Southampton to London Pipeline Project

Response to the Examining Authority's First Written
Questions Turf Hill (TH)

Application Document: 8.6.11

November 2019

TH.1.11.1: Site Plan of Colony Bog and Bagshot Heath SSSI

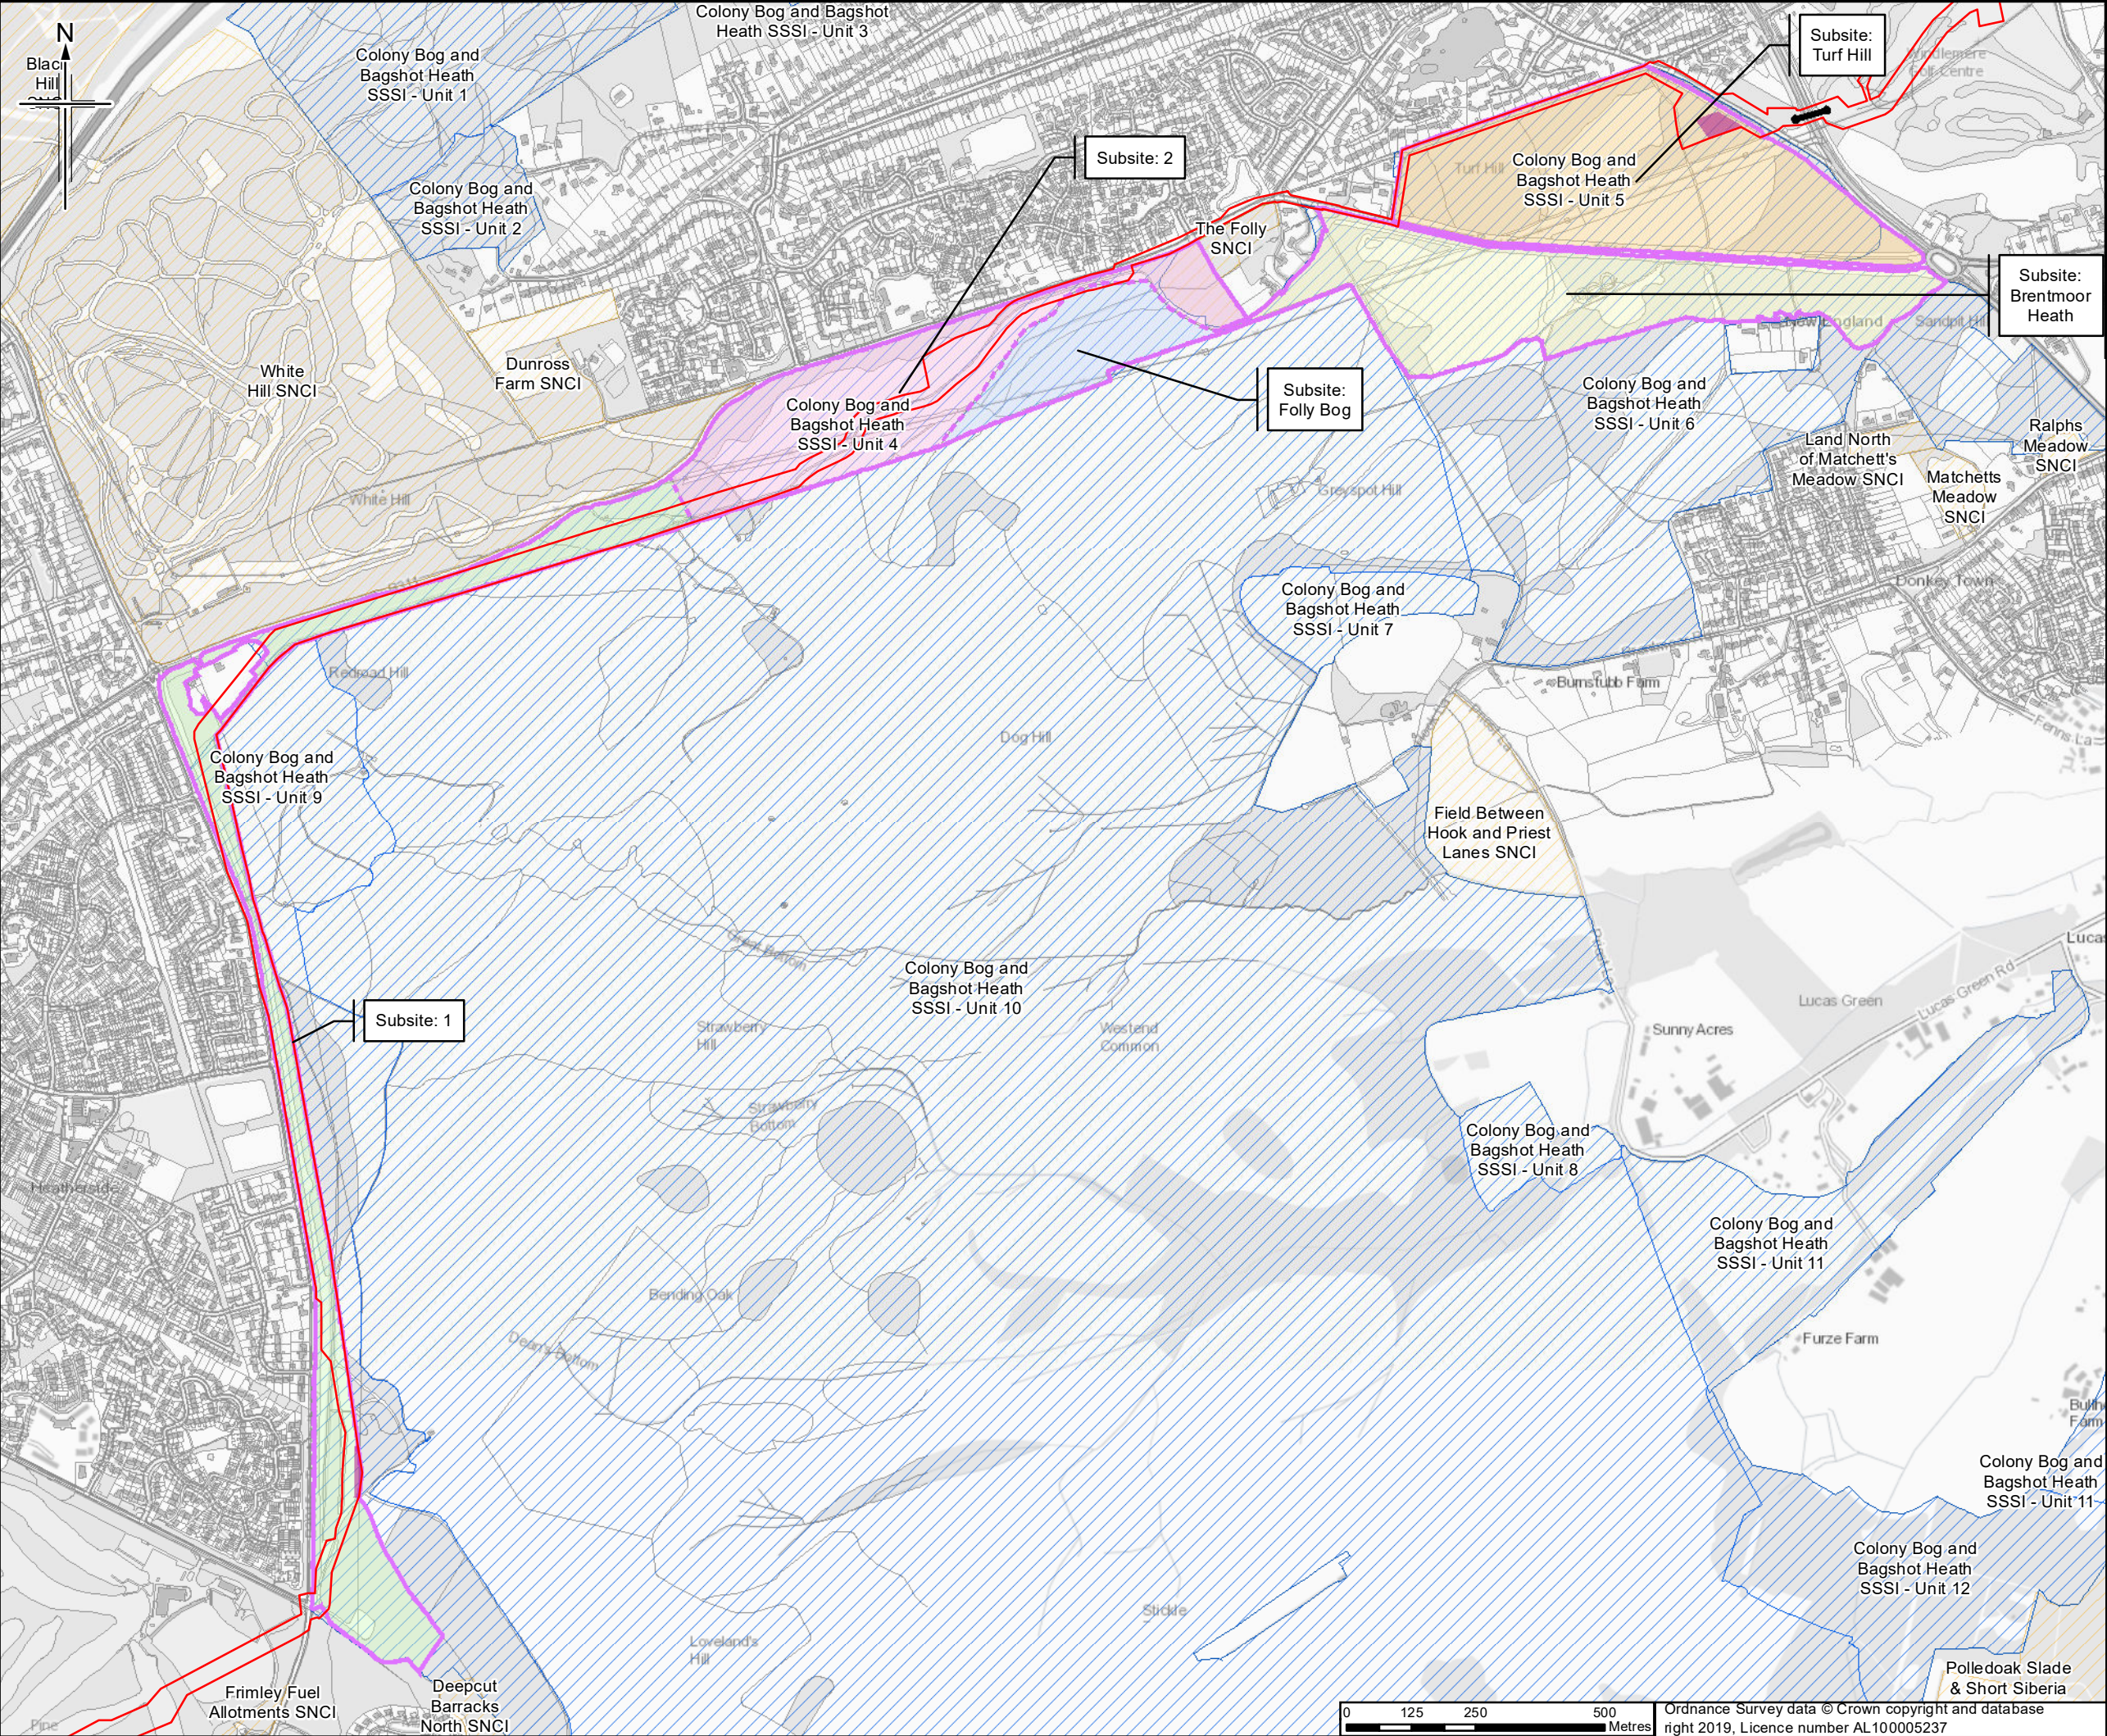
ExQ1	Question:	Applicant response to Question:
TH.1.9	<p>In Chapter 7 of the ES [APP-047] there is a reference in Table 7.6 to meetings on 18-19 October 2018 with NE to discuss, among other sites, the Colony Bog and Bagshot Heath SSSI and Turf Hill.</p> <p>Explain why there is no reference to this further advice in the additional submission [AS- 030] provided to the Examination, dated 26 July 2019.</p>	<p>1.1 Additional submission AS-030 was made by Natural England. The Applicant therefore defers to Natural England regarding the content of this submission.</p> <p>1.2 However, the Statement of Common Ground between the Applicant and Natural England (REP1-005) lists the site meetings undertaken on 18 and 19 October 2018 in Section 2.1 - Pre-application Engagement and Consultation.</p>
TH.1.11	<p>Figure A7.1.145 [APP-081] is a site plan of the Colony Bog and Bagshot Heath SSSI.</p> <p>Reproduce the Figure showing the boundaries of the subsites, and in particular the Turf Hill subsite, more clearly.</p>	<p>1.1 Figure A7.1.145 in the Phase 1 Habitats and Botany Report (Application Document APP-081) shows an overall map of Colony Bog and Bagshot Heath SSSI. The Turf Hill subsite is labelled. Subsequent figures provide zoomed in detail of Turf Hill, with its subsite boundary: Figure A7.1.146 Sheet 4 of 4 and Figure A7.1.147 Sheet 4 of 4. However, in answer to the question, the Applicant has produced a site plan of Colony Bog and Bagshot Heath SSSI showing the boundaries of the subsites (Figure TH.1.11.1).</p>
